**Electromagnetic compatibility (EMC) –  
Part 4-4: Testing and measurement techniques –  
Electrical fast transient/burst immunity test**

**CORRIGENDUM 2**

**Figure 14 – Verification of the waveform at the common mode output of the coupling/decoupling network**

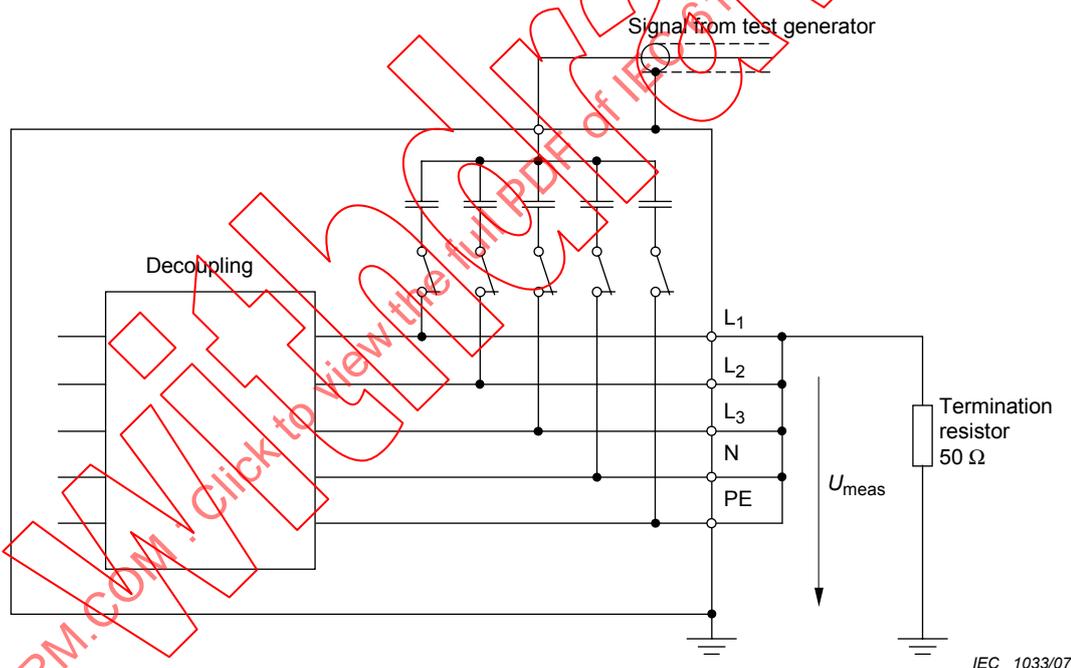
**6.2.2 Verification of the characteristics of the coupling/decoupling network**

Replace the second paragraph by the following:

The waveform shall be verified at the common mode output of the coupling/decoupling network with all outputs tied together and a single 50  $\Omega$  termination as shown in Figure 14. In addition to verification of the waveform at the common mode output of the coupling/decoupling network, it is recommended that each individual output be checked to ensure that all outputs are functional."
